STATE OF TENNESSEE DEPARTMENT OF TRANSPORTATION DESIGN DIVISION NASHVILLE, TENNESSEE 37243-0348

INSTRUCTIONAL BULLETIN NO. 13-1

Regarding New and Revised Standard Drawings

Effective immediately, the following Standard Drawings are new or revised and Section V of the Design Guidelines is revised for this update.

9-5-02 | D-CB-10RA

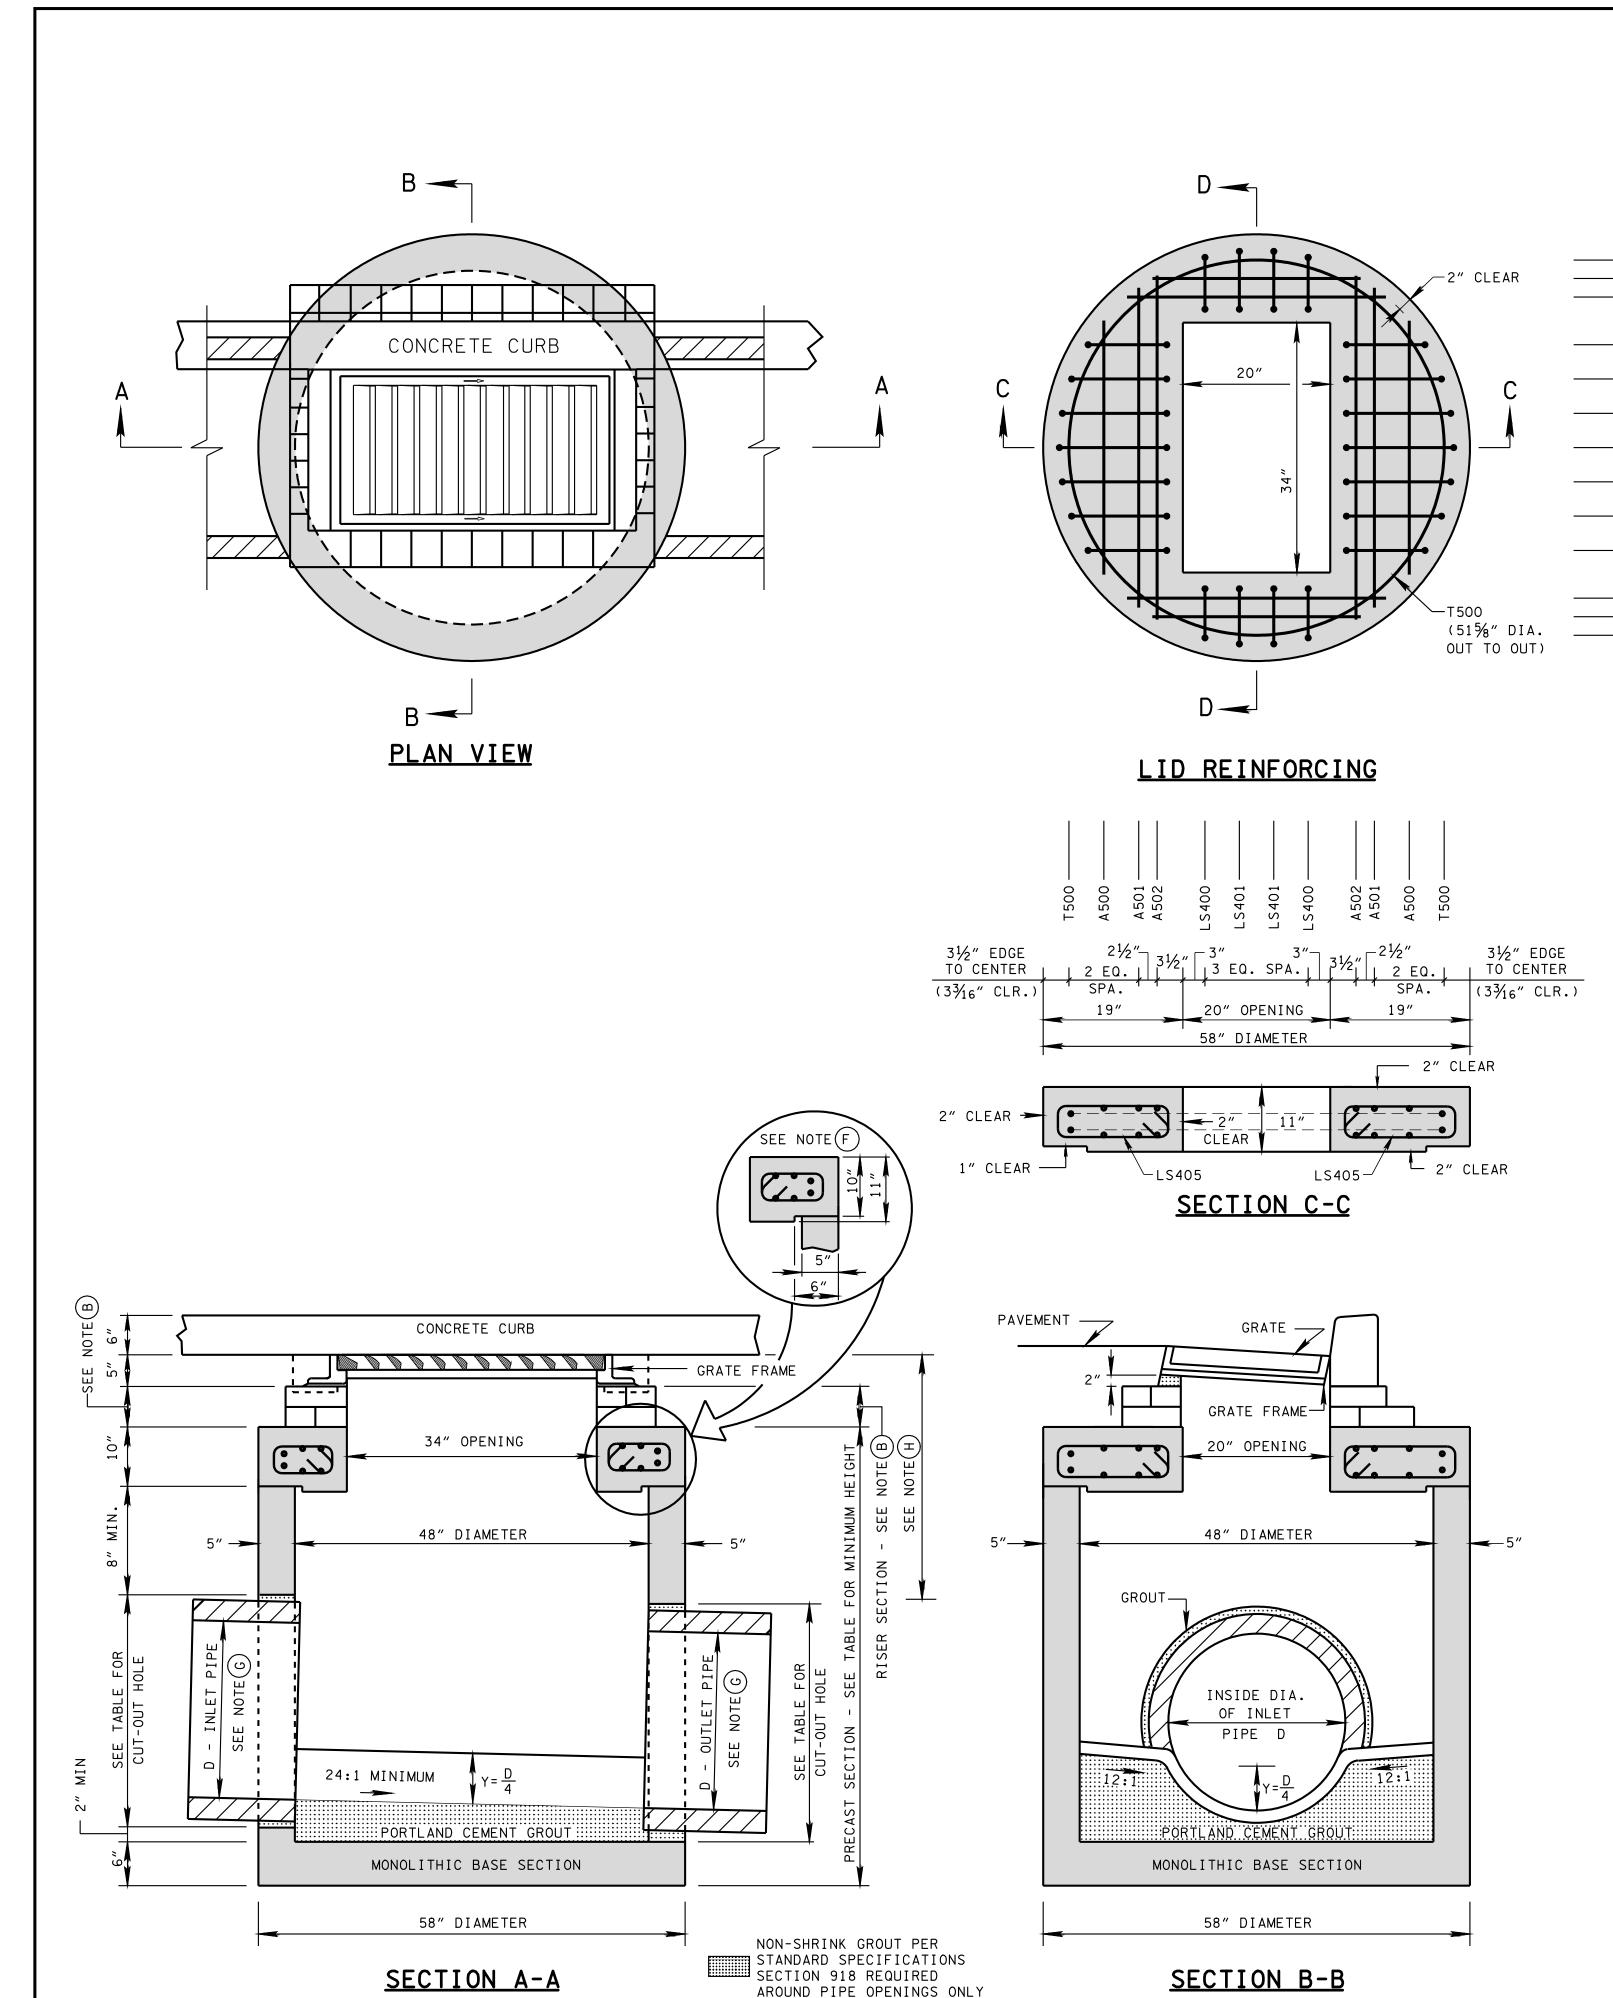
REV. 8-01-12: REVISED CATCH BASIN LID FOR COMPLIANCE WITH AASHTO LRFD BRIDGE DESIGN SPECIFICATIONS, 4TH EDITION WITH INTERIMS. REVISED REINFORCING, GENERAL NOTES AND ADDITIONAL MISC. DRAFTING EDITS.

REV. 9-24-12: MODIFIED TOP SLAB AND MINIMUM DEPTH.

10-26-97 D-CB-10S

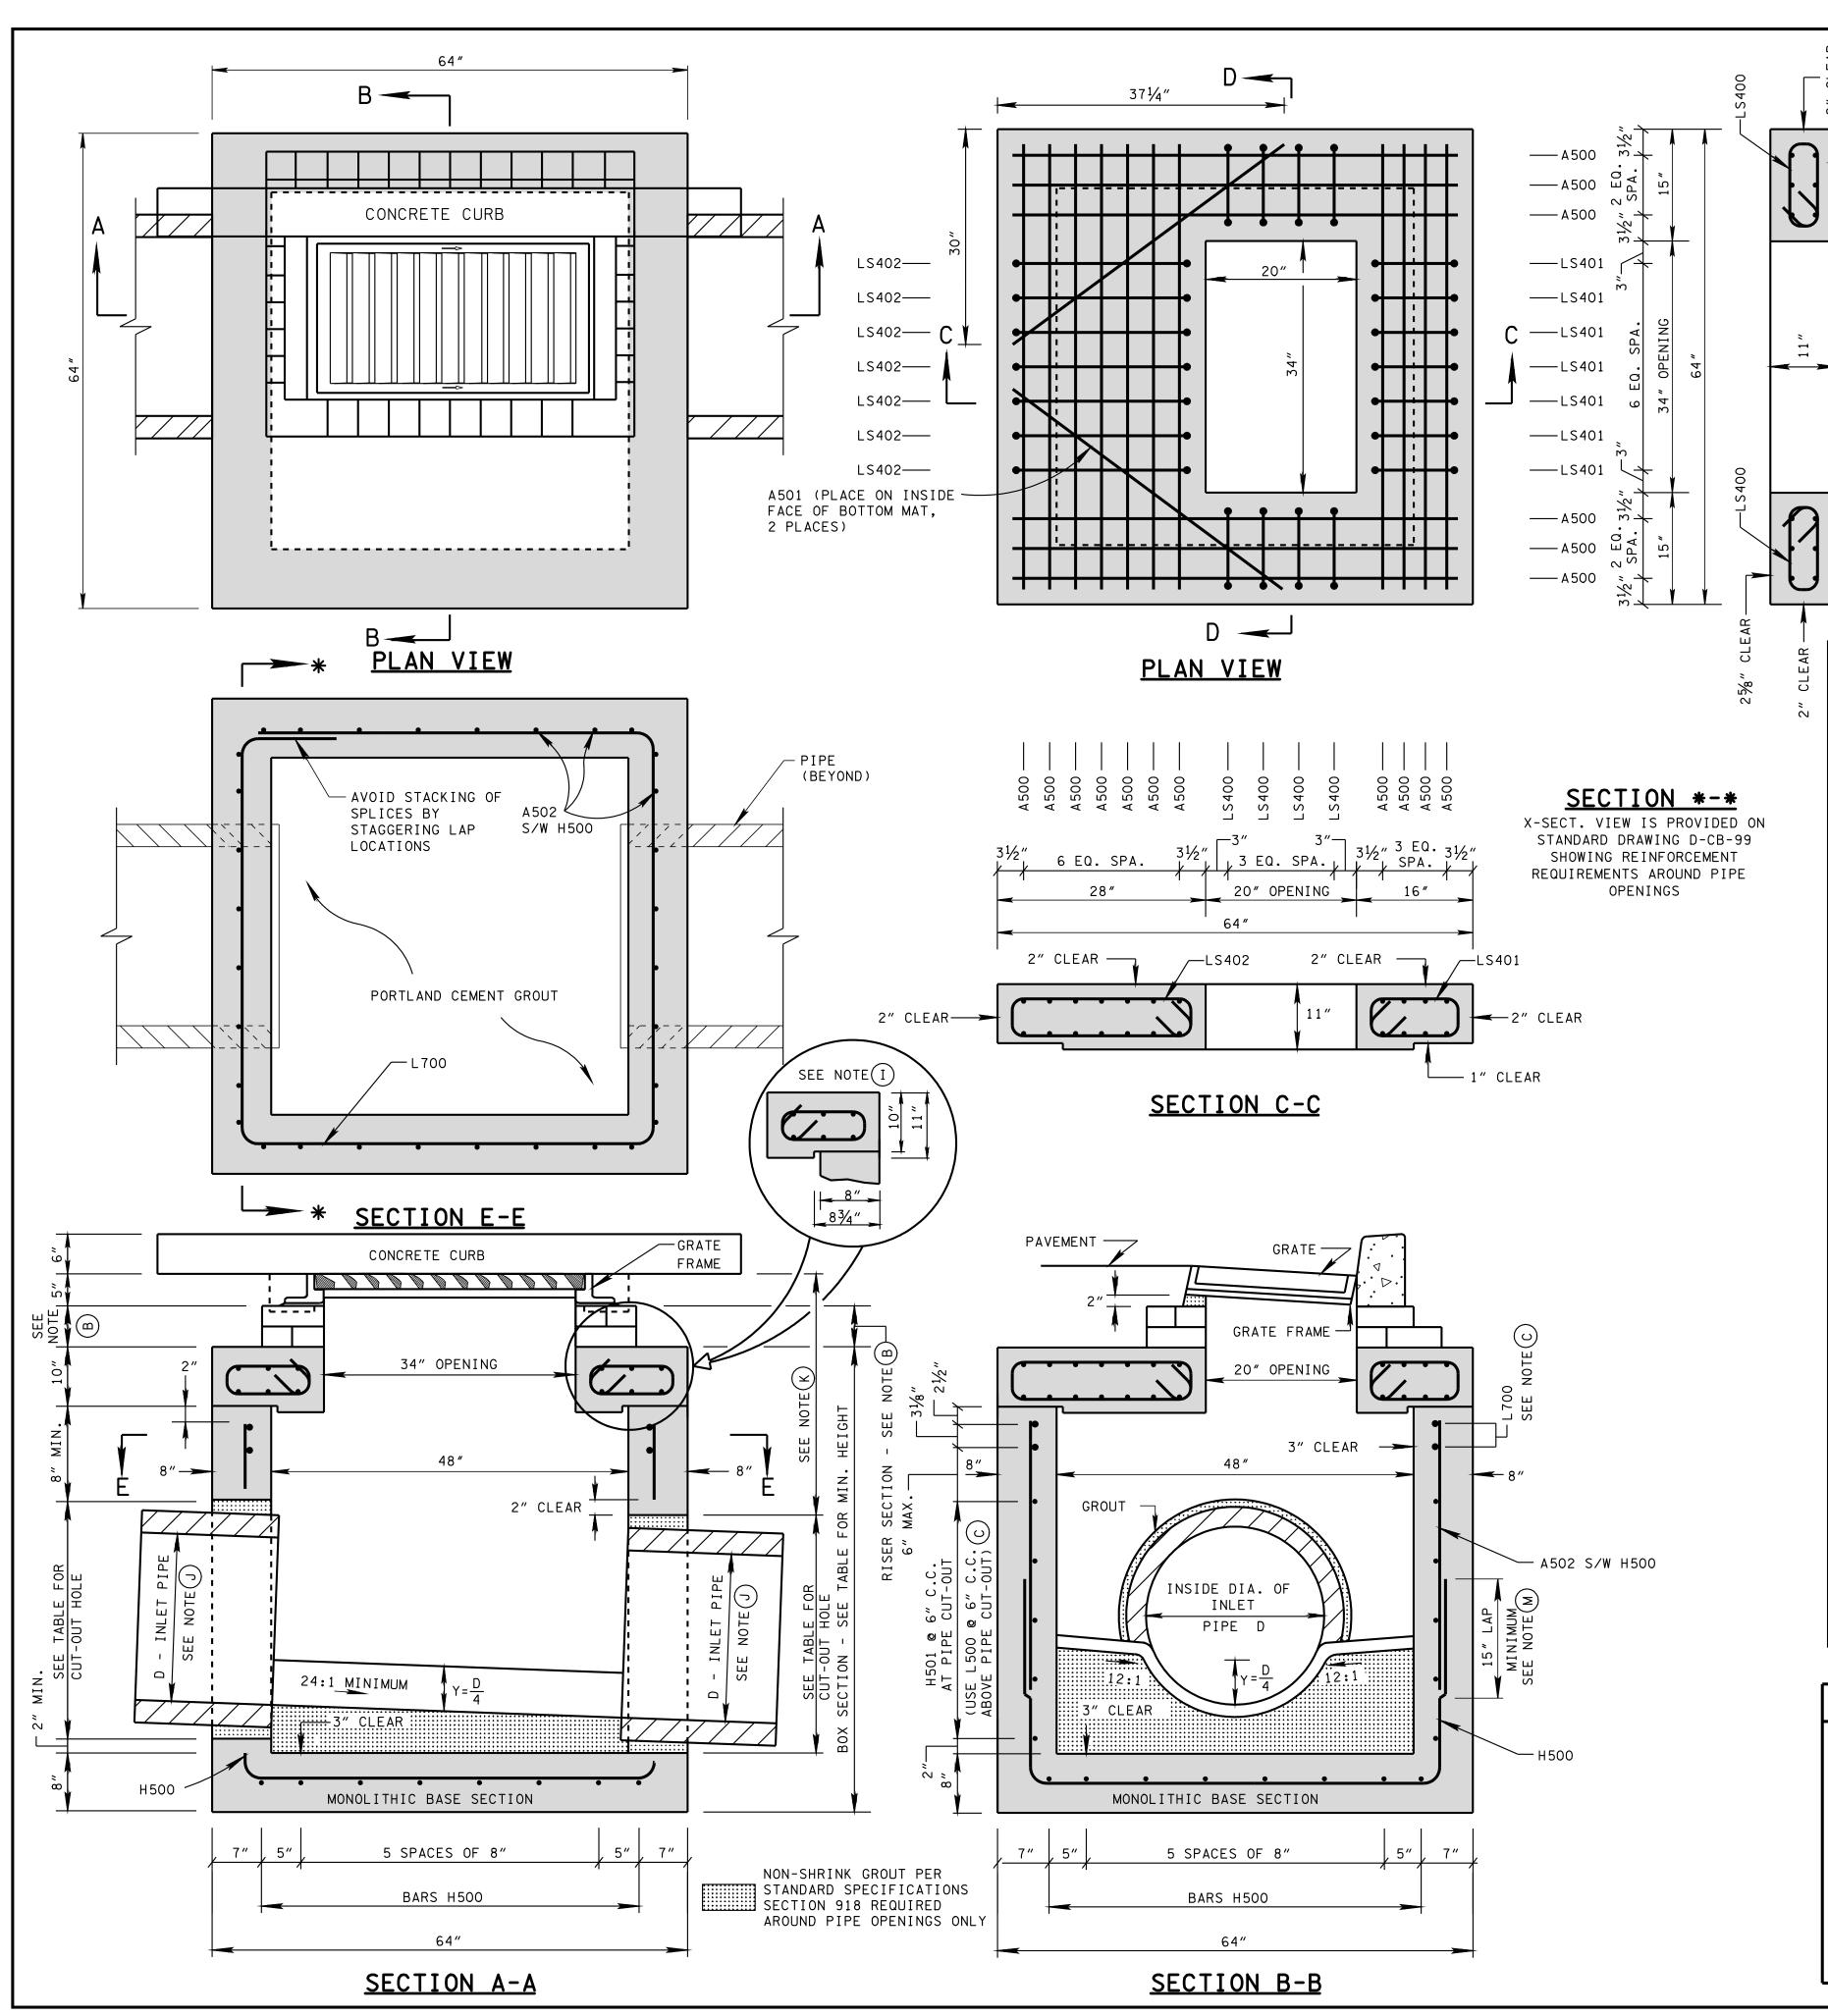
- REV. 10-26-97: MODIFIED DRAWING NO. D-CB-12S BY REMOVING CURB OPENING AND CONVERTING IT TO NO. 10 CATCH BASIN.
- ☐ REV. 1-19-99: MODIFIED CATCH BASIN MINIMUM DEPTH TABLE.
- □ REV. 5-27-01: CHANGED PAY ITEMS IN GENERAL NOTE ① ADDED CATCH BASIN MAXIMUM DEPTH NOTE.
- ☐ REV. 7-29-02: CHANGED ASTM SPECIFICATION IN GENERAL NOTE ©
- REV. 8-01-12: REVISED CATCH
 BASIN FOR COMPLIANCE WITH AASHTO
 LRFD BRIDGE DESIGN
 SPECIFICATIONS, 4TH EDITION WITH
 INTERIMS. REVISED REINFORCING,
 GENERAL NOTES, LEGEND AND

□ REV. 9-24-12: MODIFIED TOP SLAB AND MINIMUM DEPTH.

9-5-02 D-CB-10SB

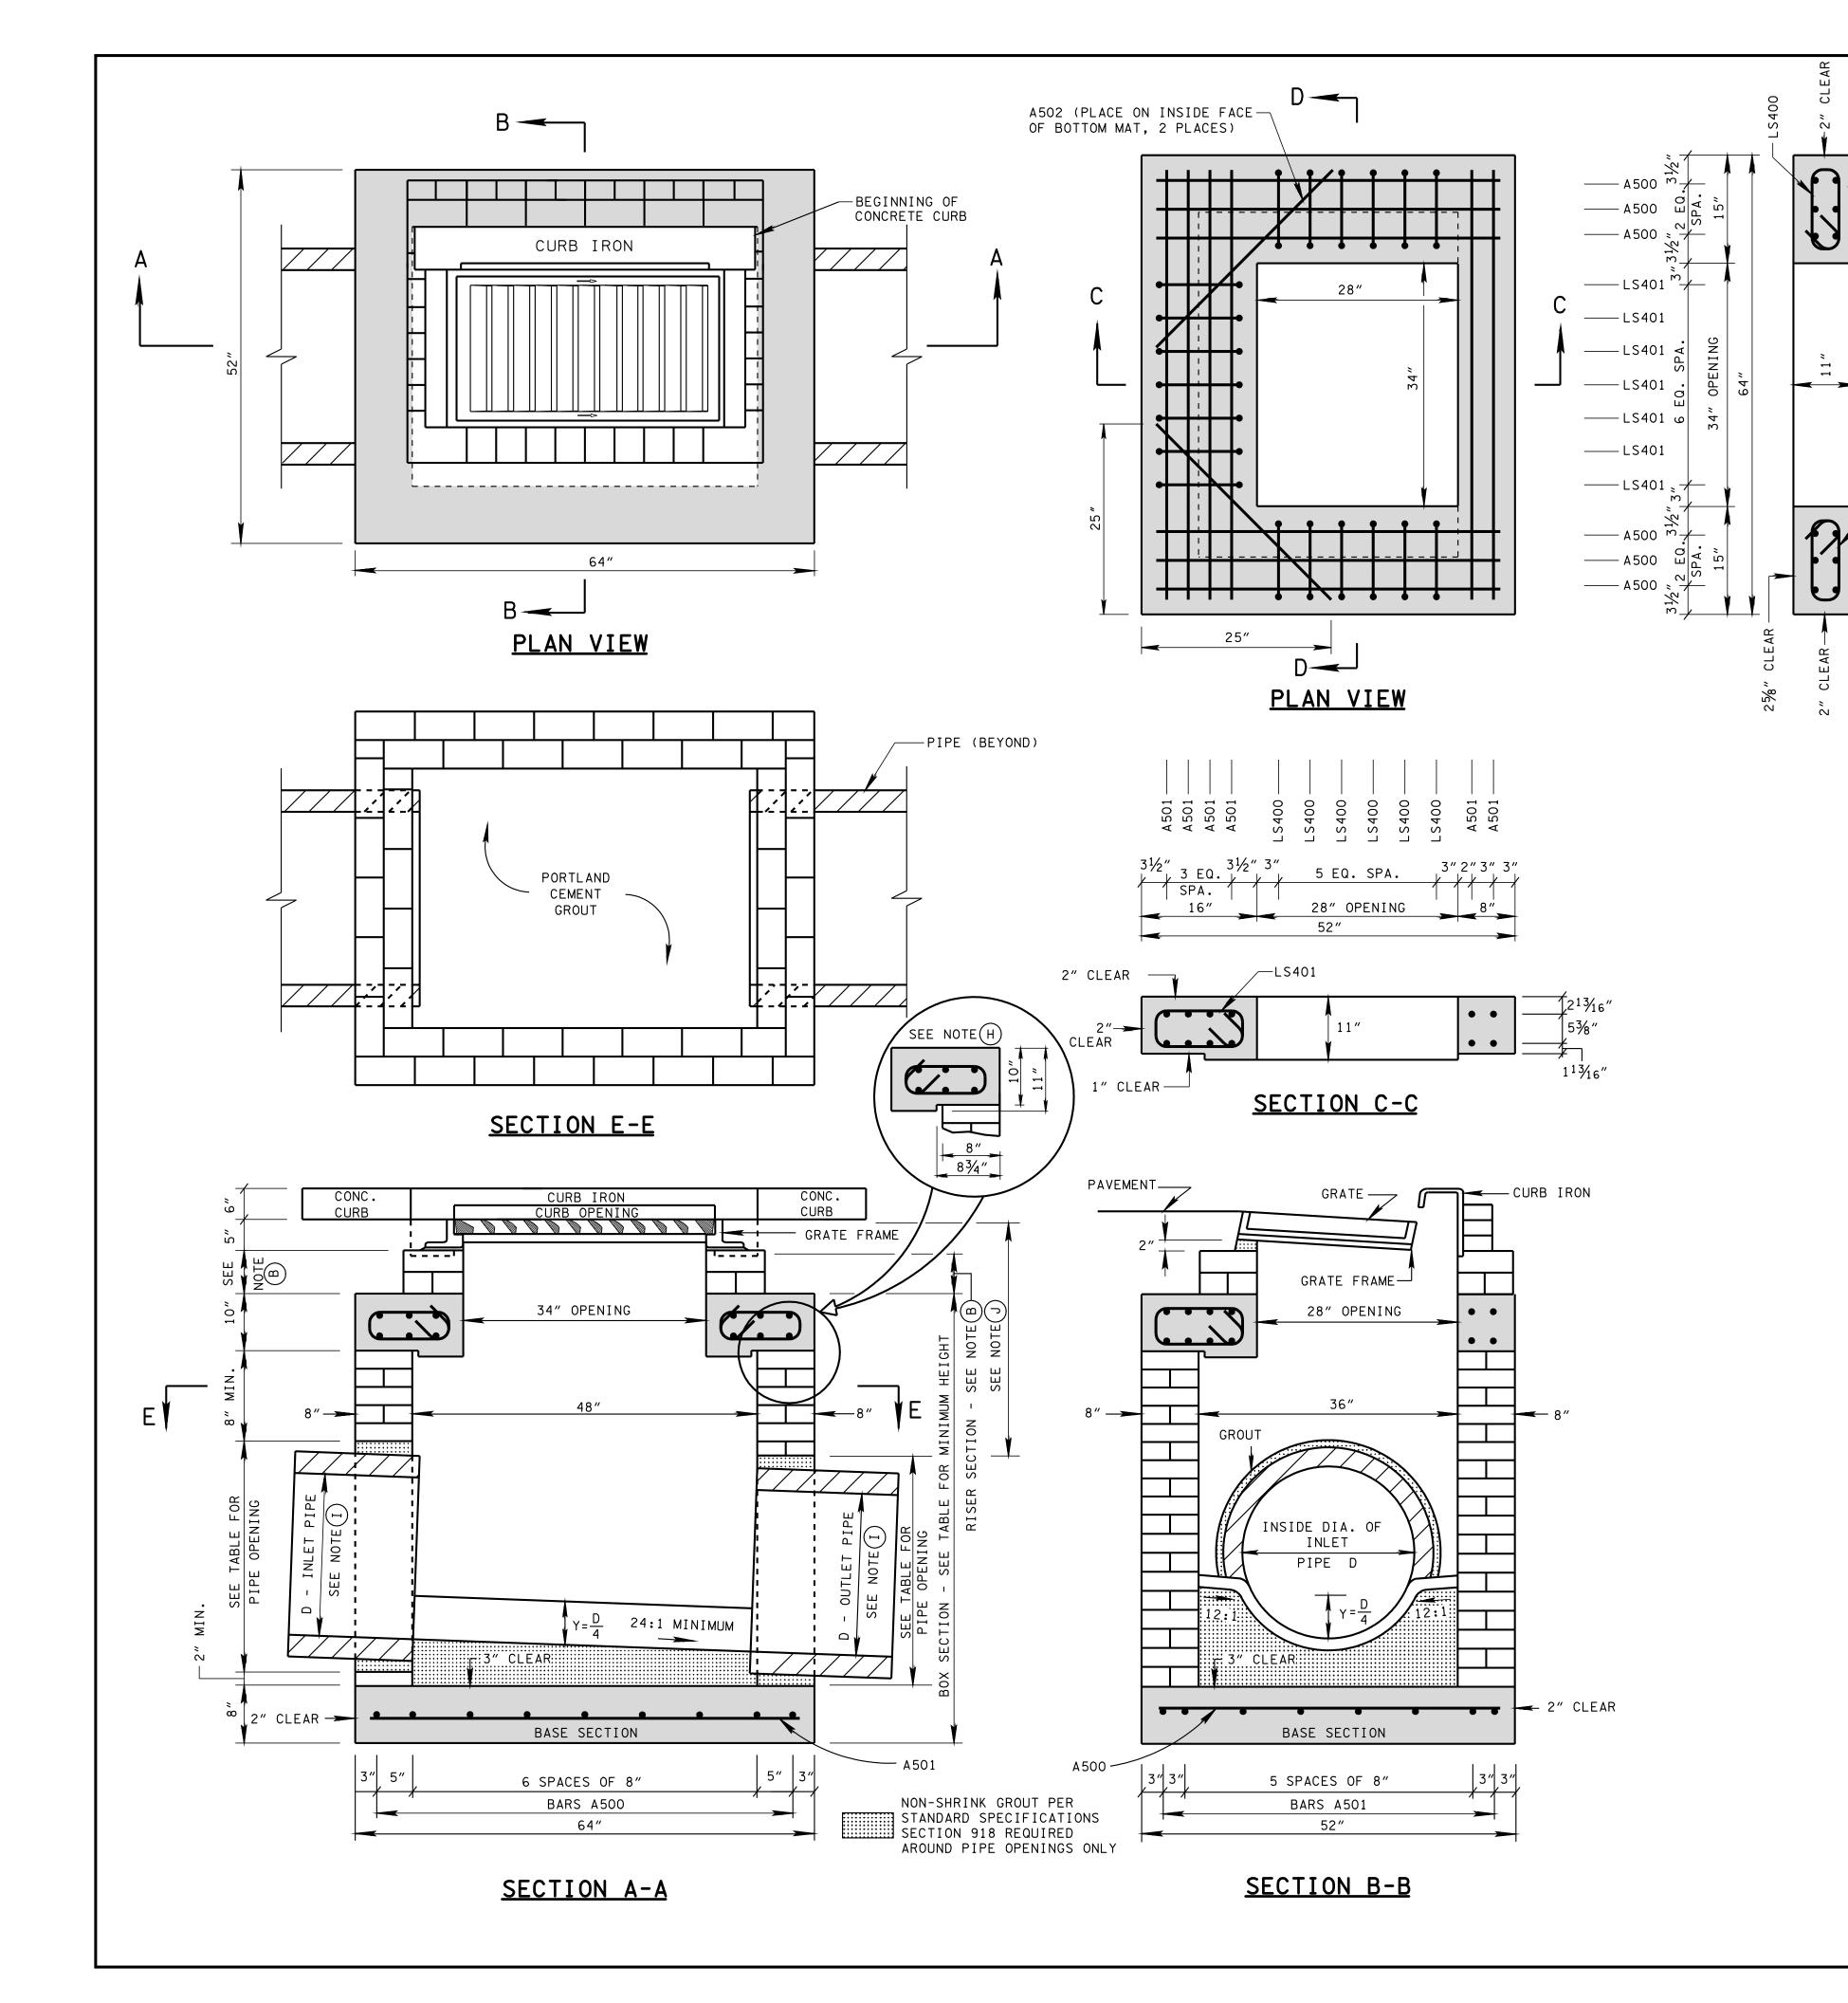
REV. 8-01-12: REVISED CATCH BASIN FOR COMPLIANCE WITH AASHTO LRFD BRIDGE DESIGN SPECIFICATIONS, 4TH EDITION WITH INTERIMS. REVISED REINFORCING, GENERAL NOTES, LEGEND AND ADDITIONAL MISC. DRAFTING EDITS.

☐ REV. 9-24-12: MODIFIED TOP SLAB AND MINIMUM DEPTH.
